**BOLLETTINO TECNICO**

N° **109EP-5**

**MODELS AFFECTED :** A109E

MODIFICATION OF ENGINE EXHAUST EJECTORS P/N 109-0601-51 BY  
APPLYING THE KIT P/N 109-0822-94.

FIGURE 1

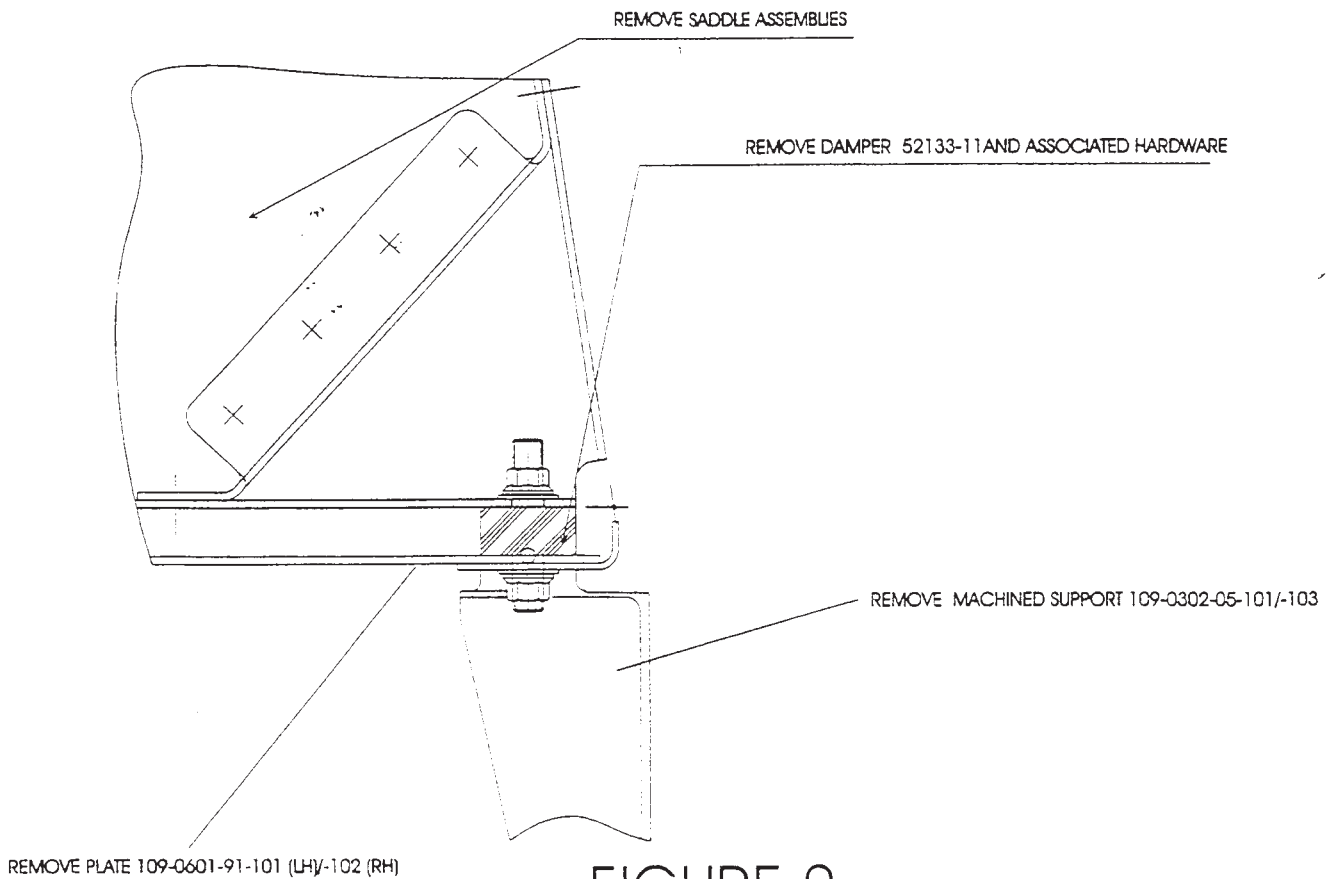
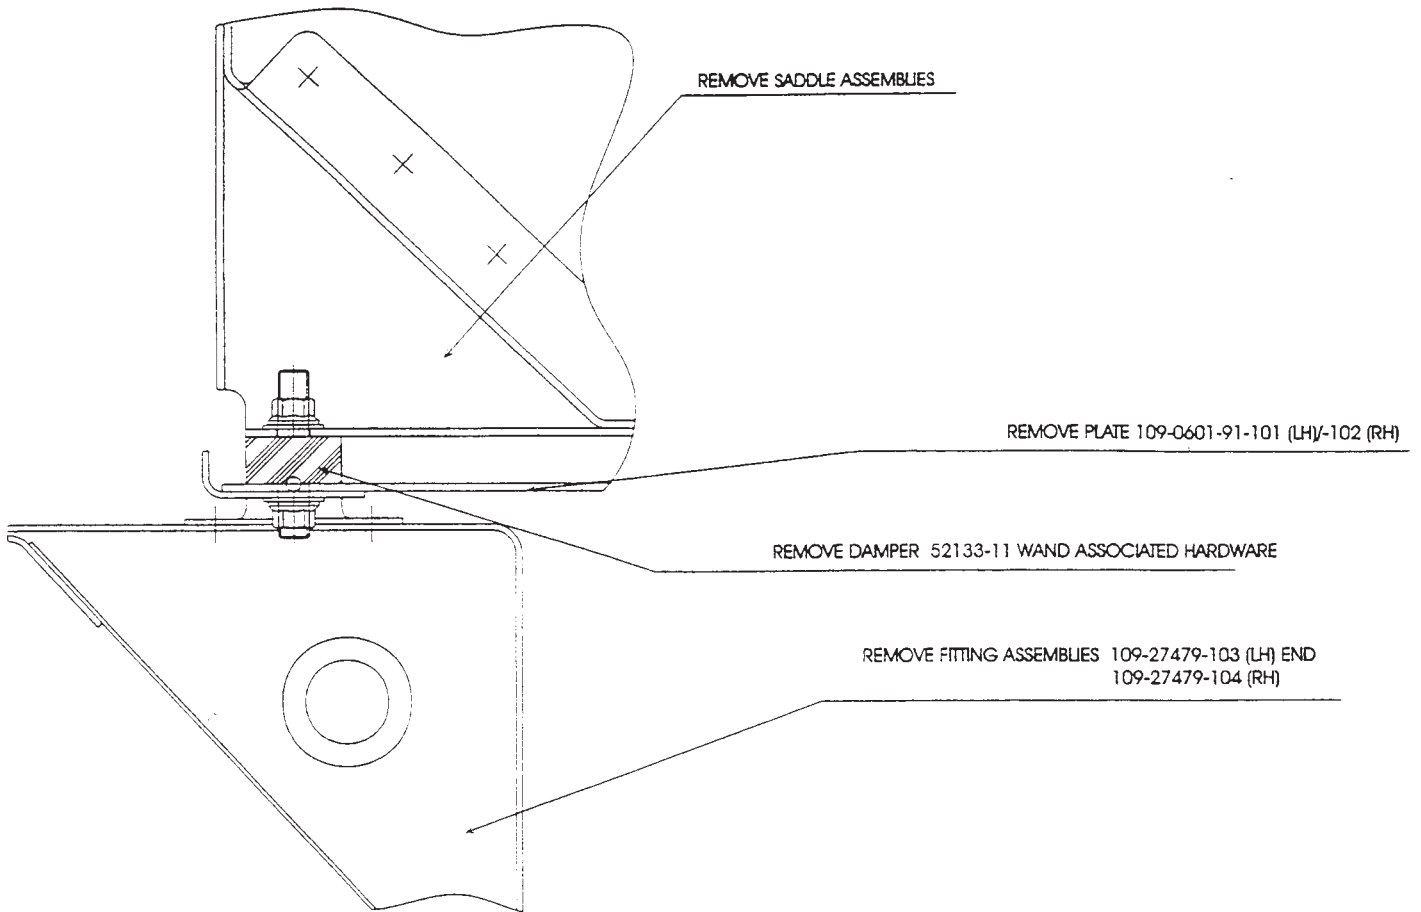
- 4.1 Remove:
- ejector from saddle; for helicopters provided with an attachment clamp, remove clamp and discard it (figure 1), for helicopters provided with attachment bolts, remove bolts and metallic strap and discard them.
  - ejector from bulkhead P/N 109-0641-46 by removing associated hardware, retain both ejector and bolts for reuse.
  - if installed, seal P/N 109-0601-52-123; from ejector and discard it (figure 1).
  - ejector saddle, plate P/N 109-0601-91 if installed, by removing damper nuts, discard items (figures 2,3 and 4)
5. If installed, disconnect and discard hose assy P/N 109-0707-84-101 of engine fire extinguisher system as indicated in figure 5.
6. Connect a new hose assy P/N 109-0707-77-101 to the engine fire extinguisher system as indicated in figure 5.
7. Rework inner support assemblies as follows:

11. For helicopters that were provided with a metallic clamp to secure ejectors-saddles (refer to figure 1), rework ejectors and saddles as follows:
  - 11.1. Match saddle P/N 109-0601-79-131 (LH) /-132 (RH) with metallic strap P/N 109-0602-18-105 and drill  $\varnothing$  5.0 mm  
Enlarge holes of metallic strap to  $\varnothing$  7.5 mm (refer to figure 12)
  - 11.2 Install saddle P/N 109-0601-79-131 (LH) and 109-0601-79-132 (RH) on relative dampers, as indicated in figure 11, by using for each damper: one (1) bolt P/N NAS 6604D20, one (1) washer P/N

FIGURE 6

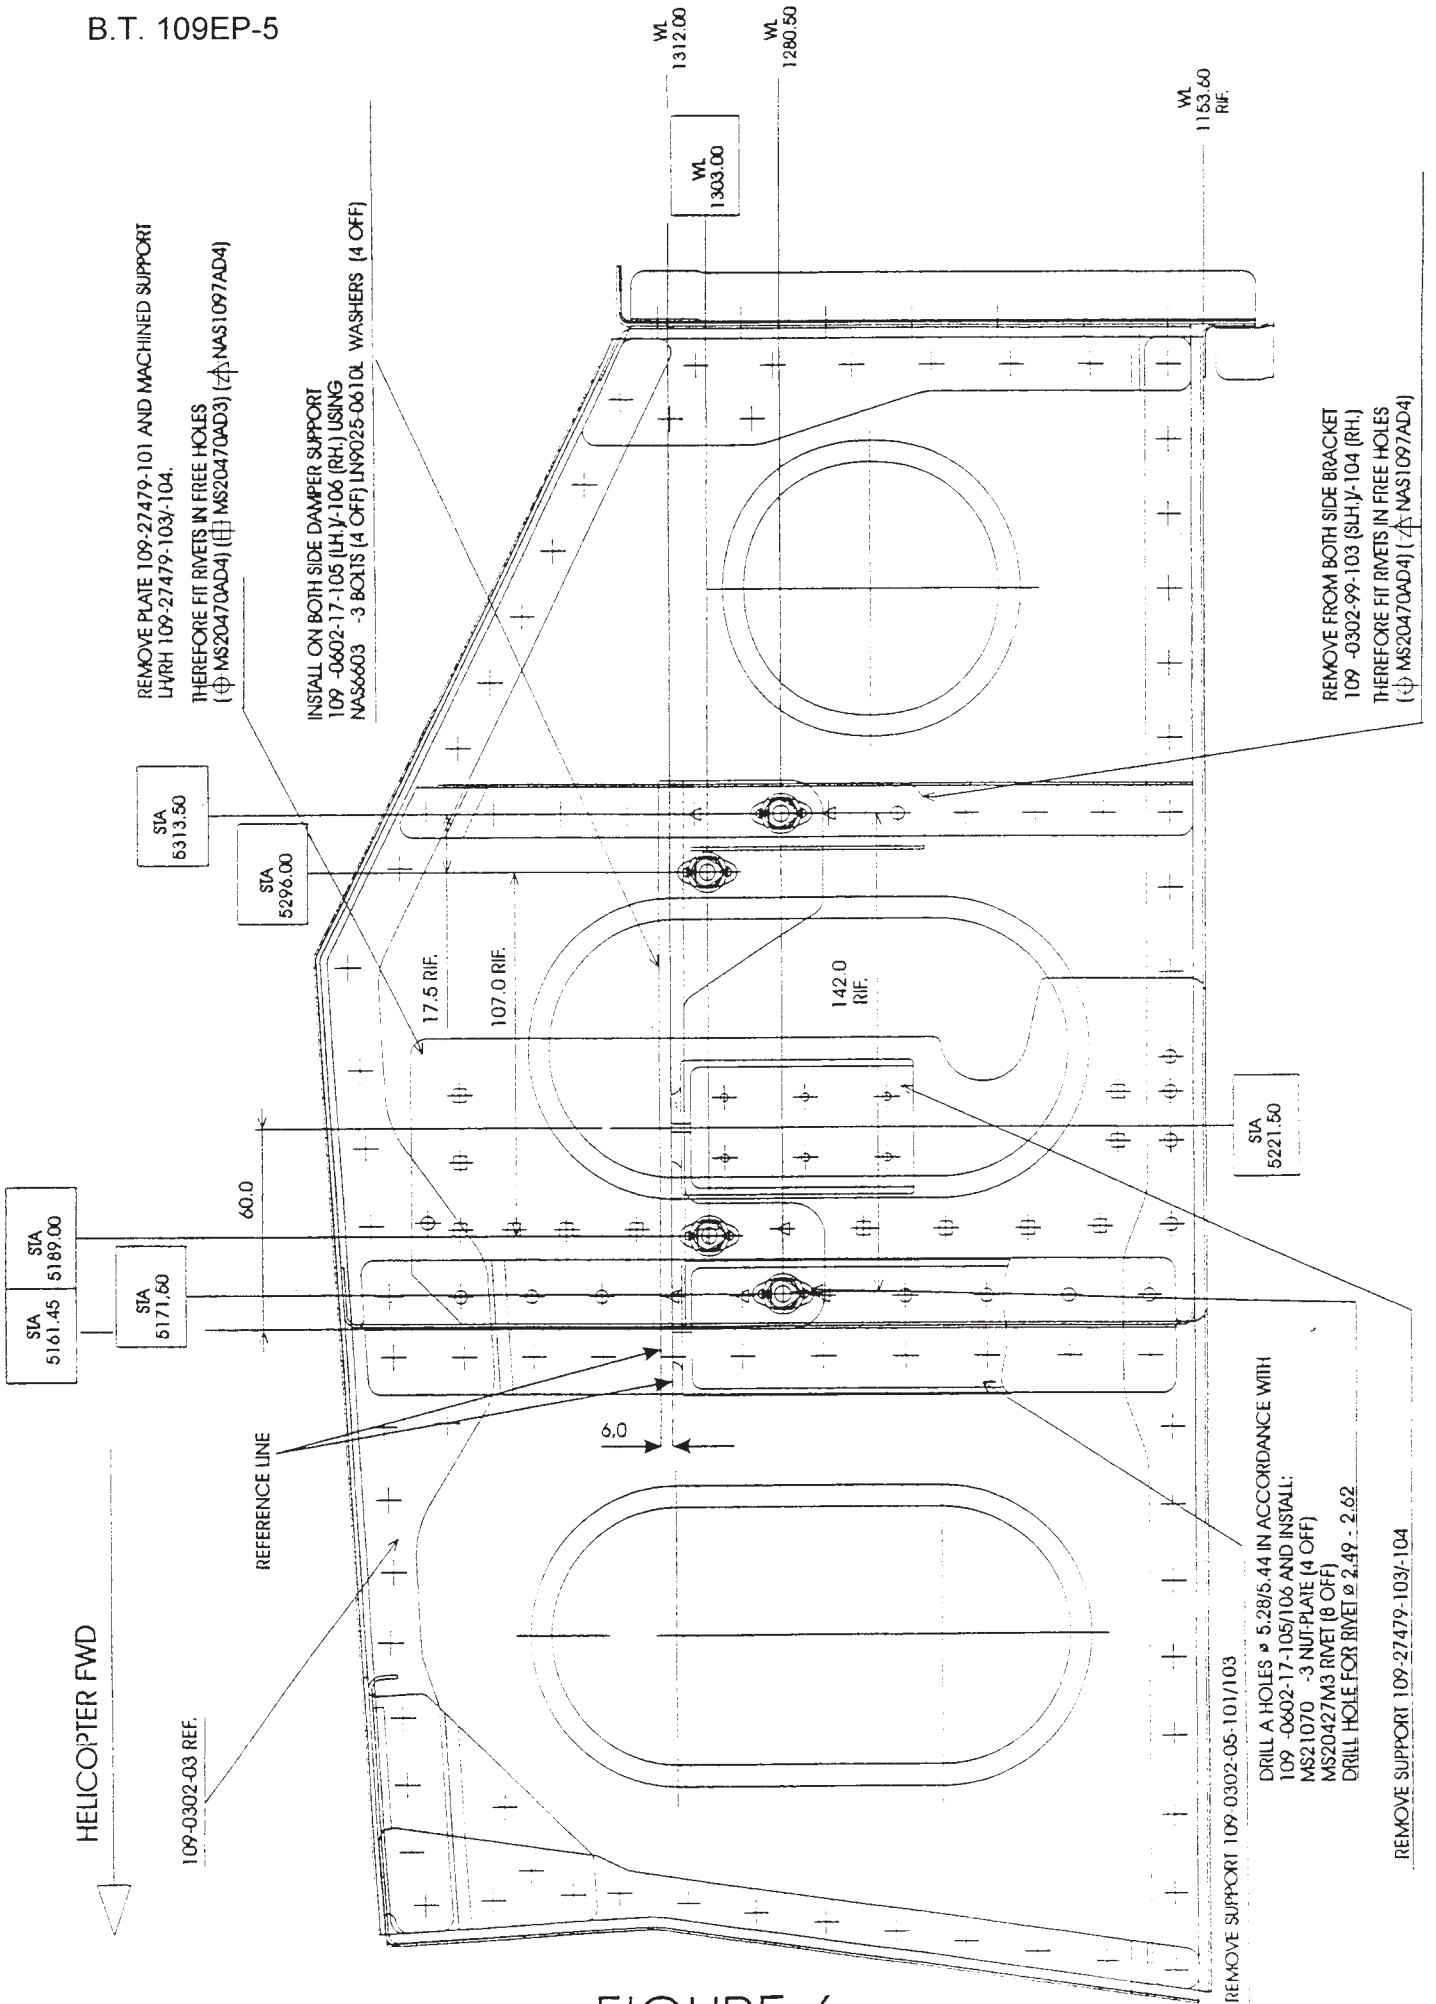
- 7.1. Mark on central beam position of support or bracket, which of the two is installed, as indicated in figures 6 and 7.
- 7.2. Mark a parallel line to the preceding marked line at a distance of 6 mm as indicated in figures 6 and 7.
- 7.3. Unrivet machined support P/N 109-0302-05-101/-103 or machined support PN 109-27479-103/-104 with relative plate P/N 109-0302-06-101/-102 or bracket P/N 109-0302-99-103/-104, which of these are installed, from central beam.
- 7.4. Position, as indicated in figures 6 and 7, new damper support P/N 109-0602-17-105 (LH) /-106 (RH). Countermark position of beam for subsequent nut-plate installation. Remove damper support and countermark beam with nut-plates.

- 7.7. Close holes left free on central beam using (refer to figure 6):
  - rivets P/N NAS 1097AD4-4 which correspond with the surface of the new supports.

- rivets P/N MS20470AD4-3 or MS20470AD3-3 to adjacent areas.
- 7.8. Secure support P/N 109-0602-17 as indicated in figure 6 by using four (4) bolts P/N NAS 6603-3 and four (4) washers P/N LN9025-0610L.

FIGURE 8

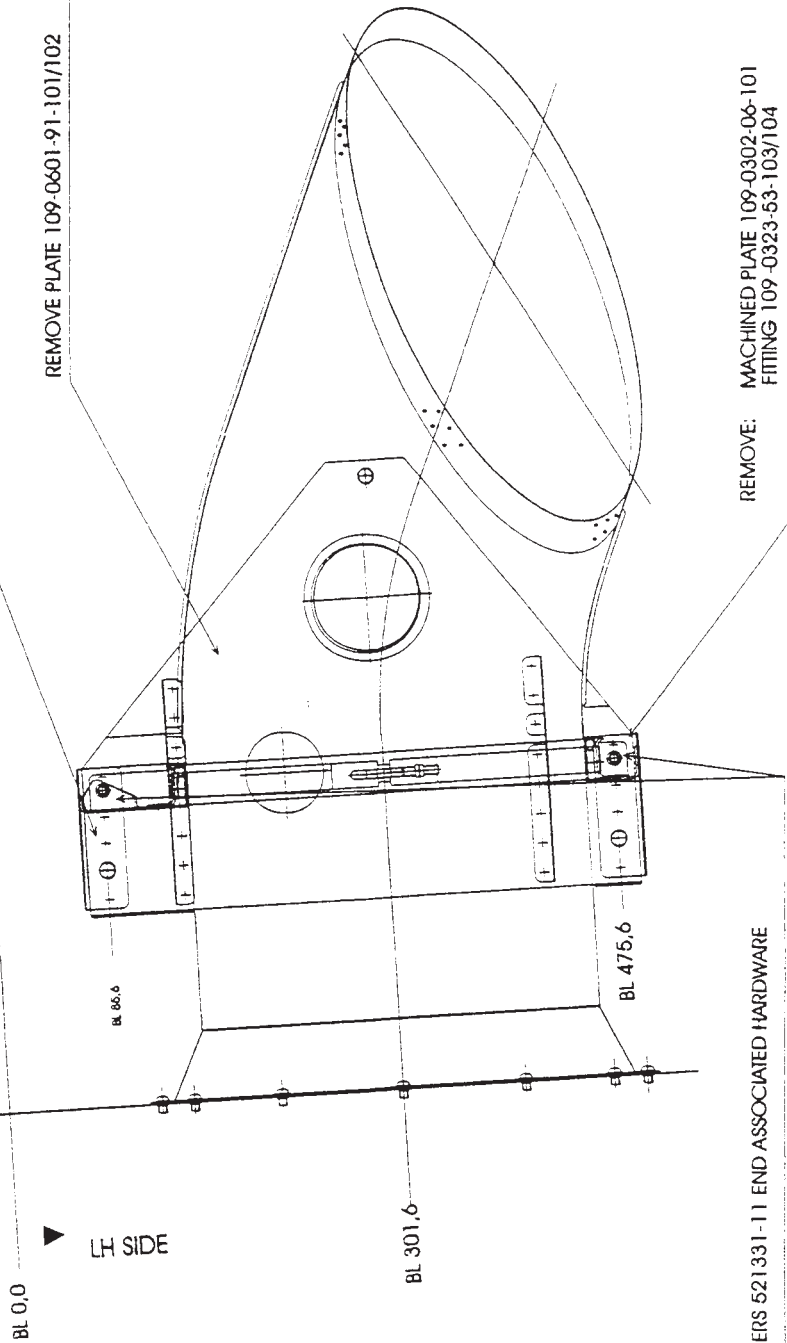
8. Rework external fitting assemblies as follows:
  - 8.1. For helicopters not provided with plates P/N 109-0601-91-101 (LH) /-102(RH) (figure 8), rework external fittings as follows:

- 8.1.5. Rivet rib to brackets using rivets P/N M7885/2-4-02.
  - 8.2. For helicopters provided with plate P/N 109-0601-91-101 (LH /-102) (RH) (figure 8), rework external fittings as follows:

FIGURE 9

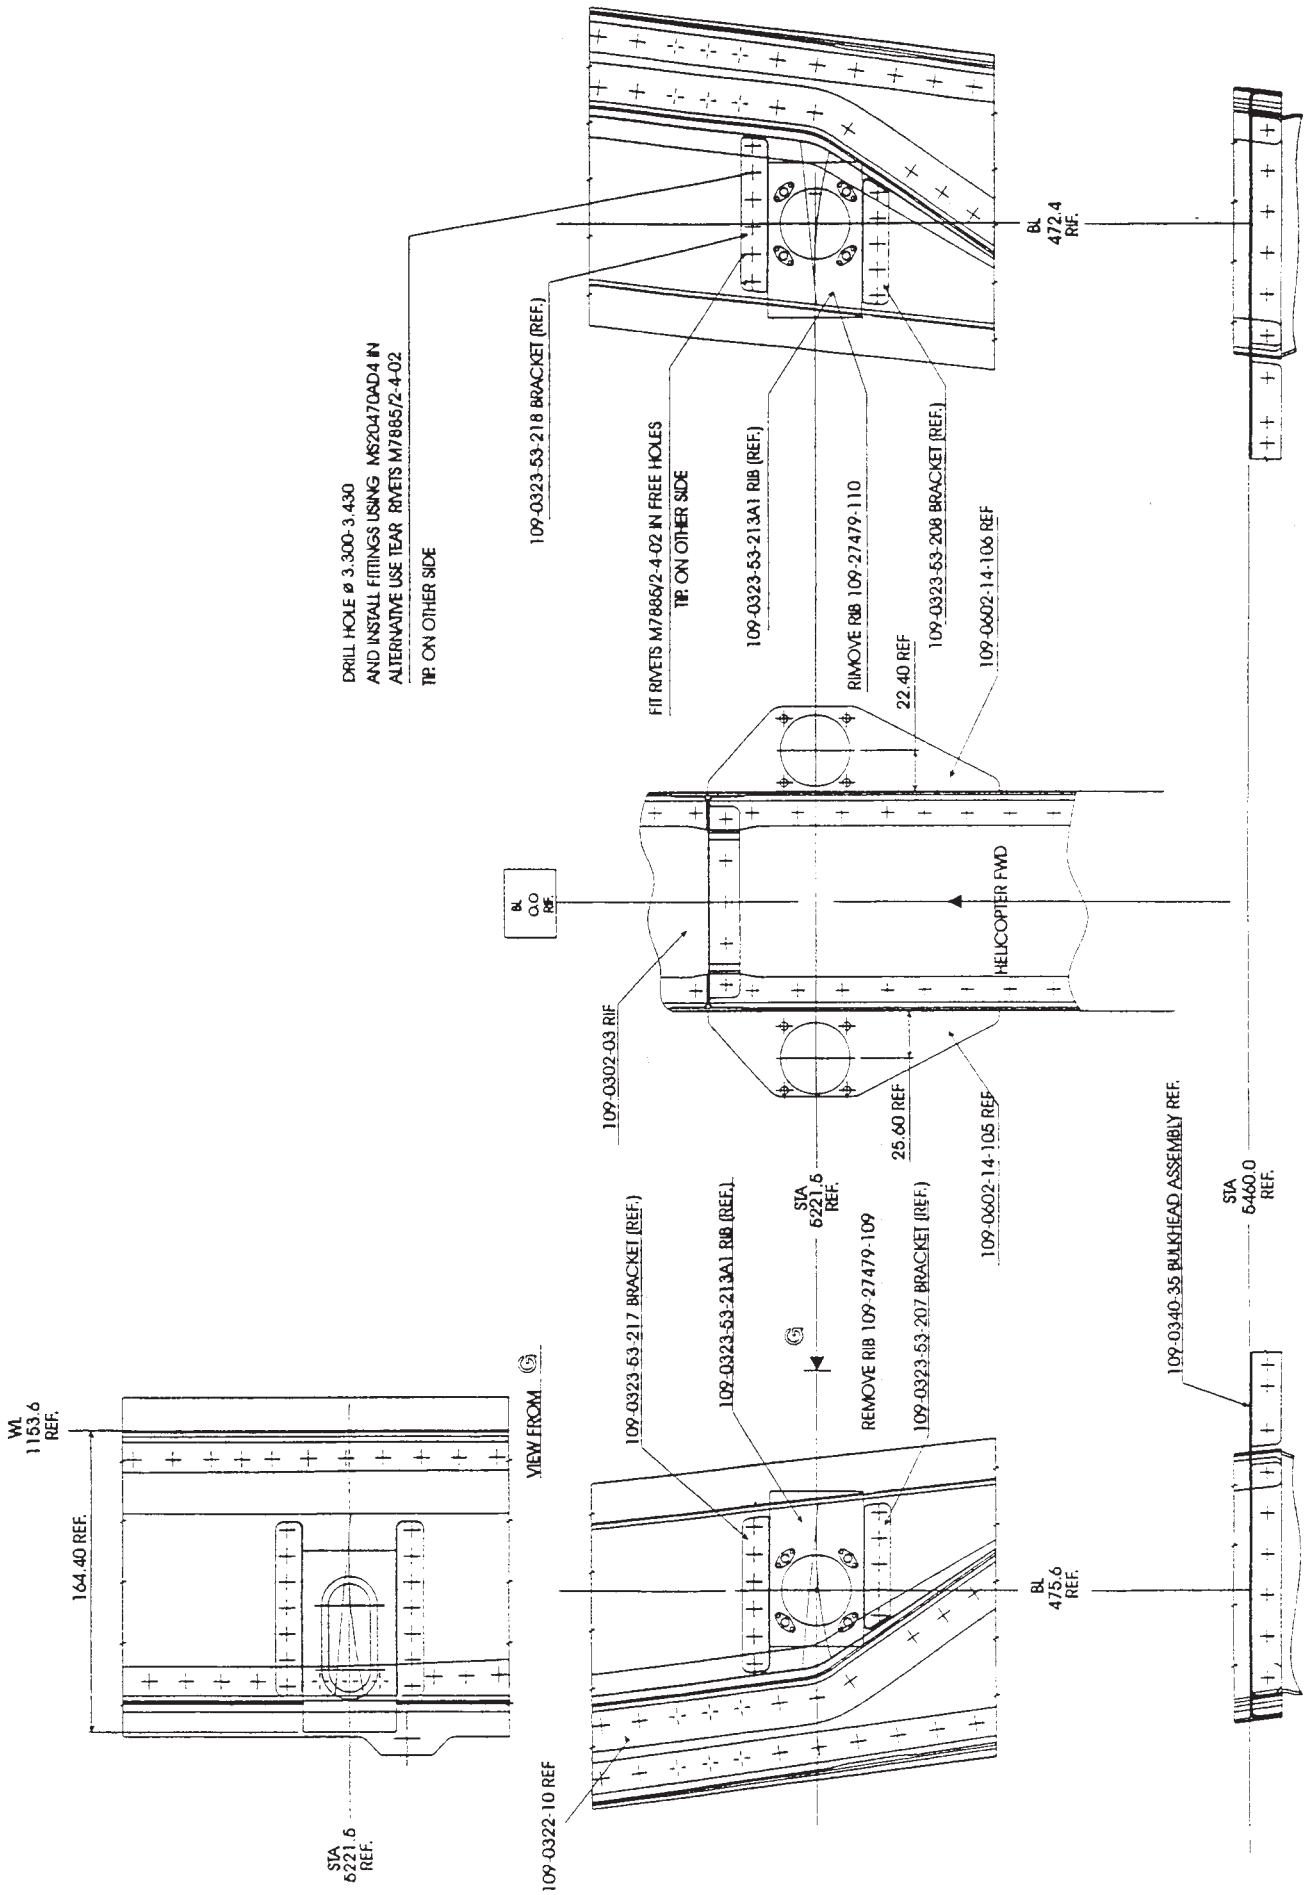
- 8.1.1. Unrivet rib P/N 109-27479-109 (LH) /-110 (RH) from brackets (refer to figure 9)
    - 8.1.2. Install tool P/N 109-3600-36-101 on support P/N 109-0602-17 as indicated in figure 10 and level it by using adjustment handle.

- 8.2.3. Fill free holes using rivets P/N M7885/2-4-02.
  - 8.2.4. Install tool P/N 109-3600-36-101 on support 109-0602-17 as indicated in figure 10 and level it by using the adjustment handwheel .  
Ensure to position tool parallel to bulkhead assy (refer to figure 9).

- 8.2.5. Install rib P/N 109-0323-53-213A1 (LH and RH) on centering assy P/N 109-3600-36-115 and position fwd bracket P/N 109-0323-53-217 (LH) /-218 (RH) on beam as indicated in figure 9. Countermark beam with bracket.

- 8.2.6. Position aft bracket P/N 109-0323-53-207 (LH/ -208 (RH) on beam as indicated in figure 9.  
Countermark beam with bracket.
  - 8.2.7. Drill beam  $\varnothing$  3.30 to 3.43 mm and secure brackets to beam using rivets P/N MS 20470AD4 or in alternative rivets P/N M7885/2-4-02.
